High-frequency operation of Frequency Stabilization Servo

Paul Schwinberg and Rick Savage, LIGO Hanford Observatory
January 29, 2003

Modified on April 15, 2003 to include Appendix A.

Figure 1 Measured H1 FSS open loop transfer function.

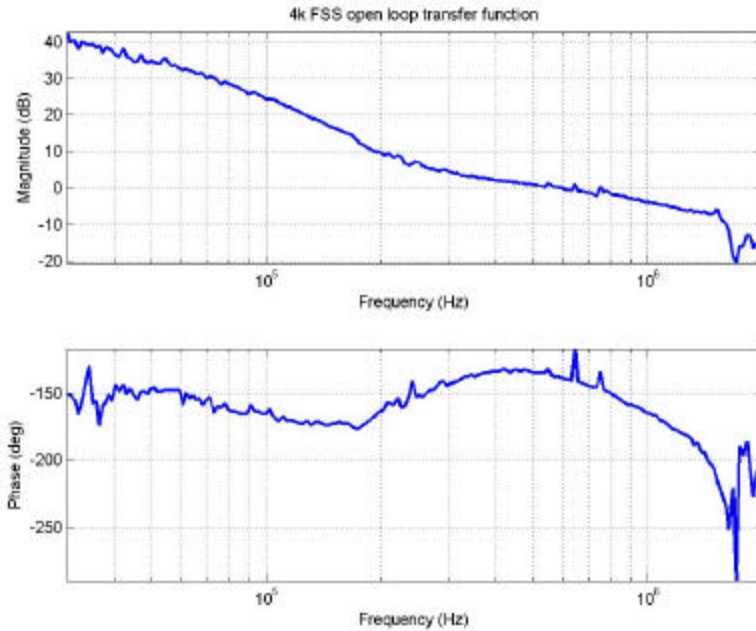
Revised FSS cards have been installed, tested, and are presently operating in both the H1 and H2 PSLs. The unity gain frequencies for both cards are about 600 kHz, the phase margins are about 40 deg. and the gains at 100 kHz are about 25 dB. The measured open loop transfer functions can be found in the LHO elog for the H2 FSS at http://blue.ligo-wa.caltech.edu/ilog/pub/ilog.cgi?group=detector&date_to_view=12/27/2002&anchor_to_scroll_to=2002:12:27:22:57:35-rick and for the H1 FSS at http://blue.ligo-wa.caltech.edu/ilog/pub/ilog.cgi?group=detector&date_to_view=01/17/2003&anchor_to_scroll_to=2003:01:18:00:07:07-rick

The H1 FSS open loop transfer function is shown in Figure 1, below.

Figure 2 FSS actuator transfer function calculated from open loop transfer function.

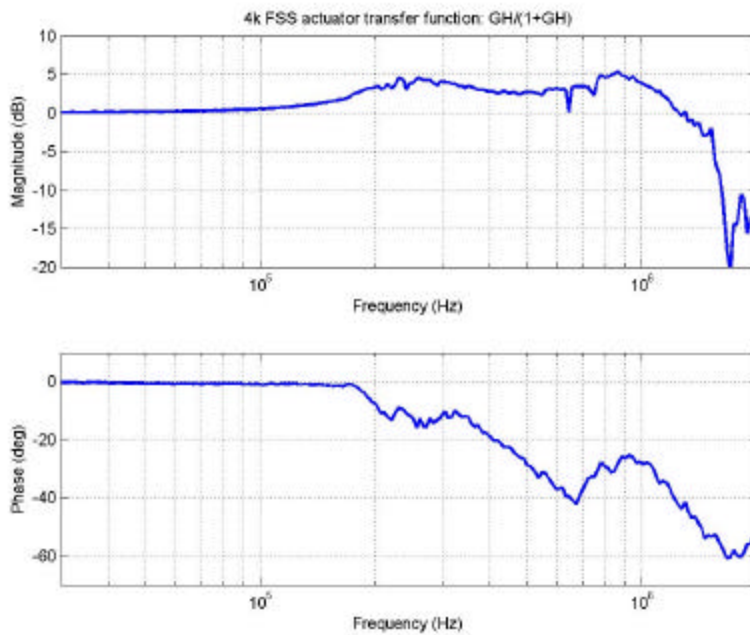
The FSS actuator transfer function (neglecting the VCO and AOM) is estimated by calculating $GH/(1+GH)$ where GH is the open loop transfer function. For the H1 FSS, this is shown in Figure 2, below.
